## **Pre-Bid Addendum #2**

- A. Bidder: \_\_\_\_\_
- B. Project Name: Mount Kisco Water Department Building Addition
- C. Project Location: 40 Columbus Avenue, Mount Kisco NY 10549
- D. Owner: The Village/Town of Mount Kisco
- E. Architect: Bar Down Studio

VILLAGE/TOWN OF MOUNT KISCO  
WATER DEPARTMENT BUILDING ADDITION  
43 COLUMBUS AVE, MOUNT KISCO, NY 10549

FIRST FLOOR  
CONSTRUCTION  
PLAN AND  
ALTERNATE

2 First Floor Plan - Alternate  
SCALE 1/4" = 1'-0"

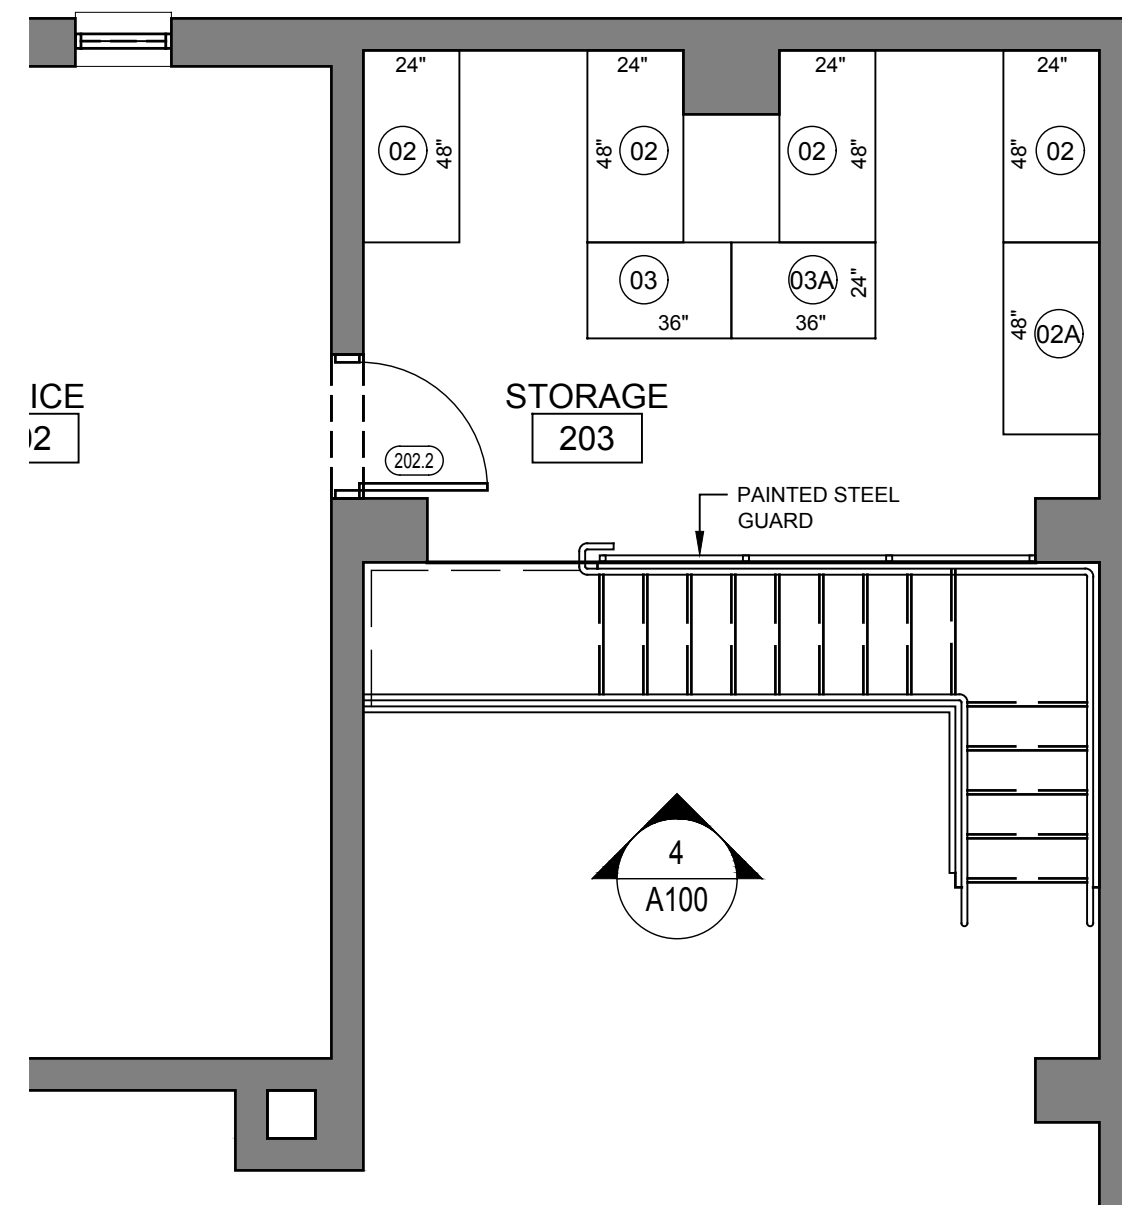
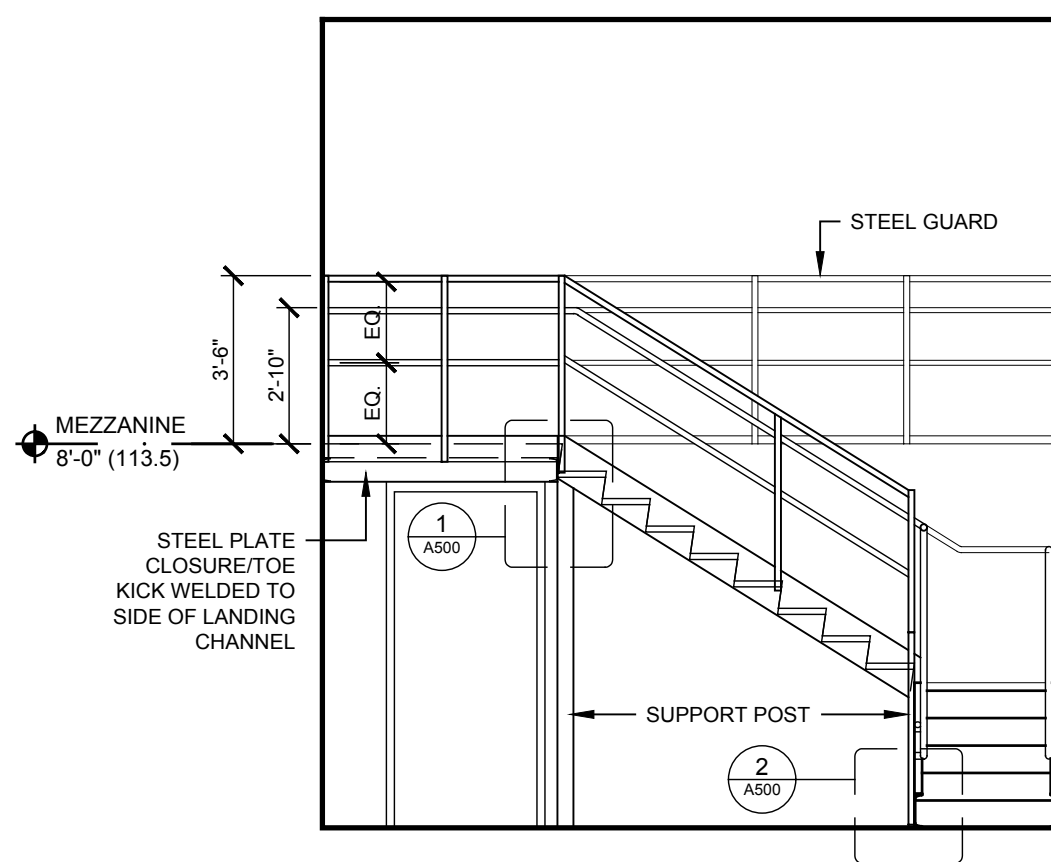
- a. Remove requirement for Performance Bond as part of Bid Package.
5. Is the new proposed storage room #111 going to be built on the raise existing slab or are we removing the slab and bring the elevation of the floor lower? The reason we are asking for clarification is that detail # 4 on Plan A-100 shows the new door # 111.1 on the Bay slab level. Please advise.

- a. Details 3/A100 and 4/A100 are clearly marked 'Alternate'. Base Bid includes the construction of Storage 111 at existing slab elevation; Alternate includes removal of slab and construction of Storage 111 at bay elevation.

1 First Floor Plan - Base Bid  
SCALE 1/4" = 1'-0"

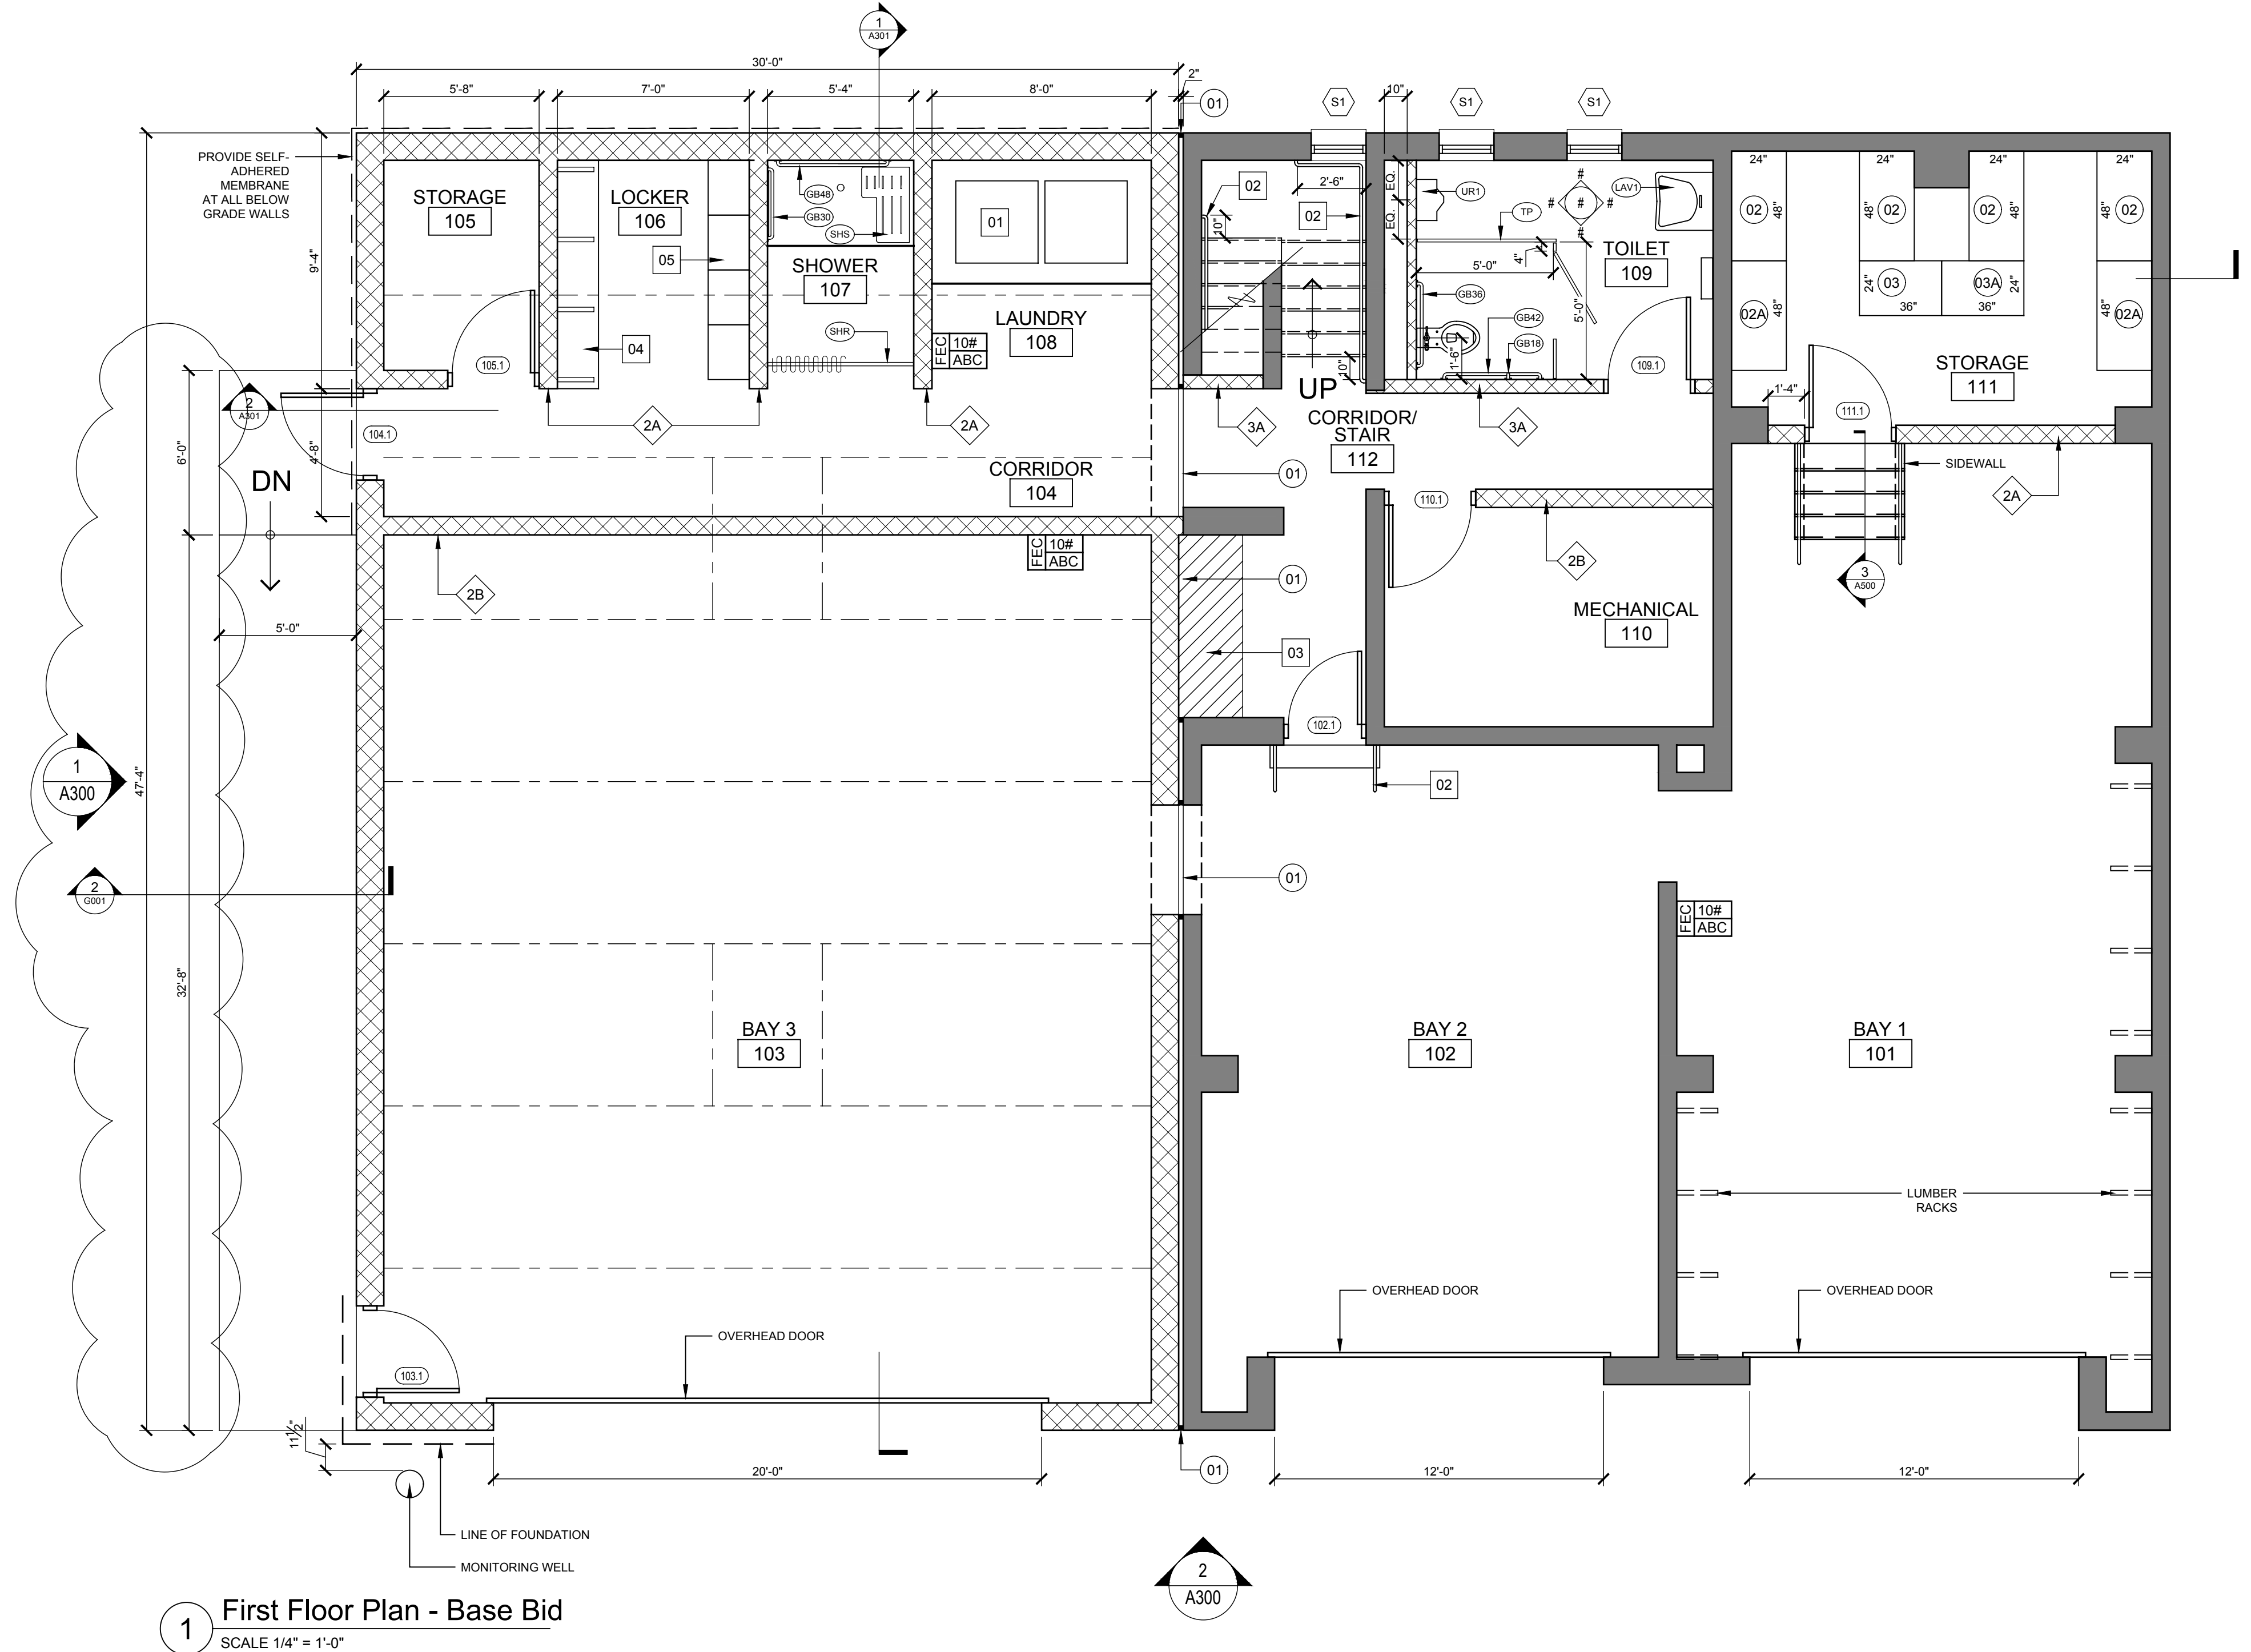
1. There is a detail for sidewalks shown on drawing G001, however, there are no sidewalks shown on the plans. Please advise.
  - a. Sidewalk is shown adjacent to the addition on Detail 1/A100; see revised drawing for additional dimensions.

9. **Revise** Drawing A100 to include sidewalk dimensions.
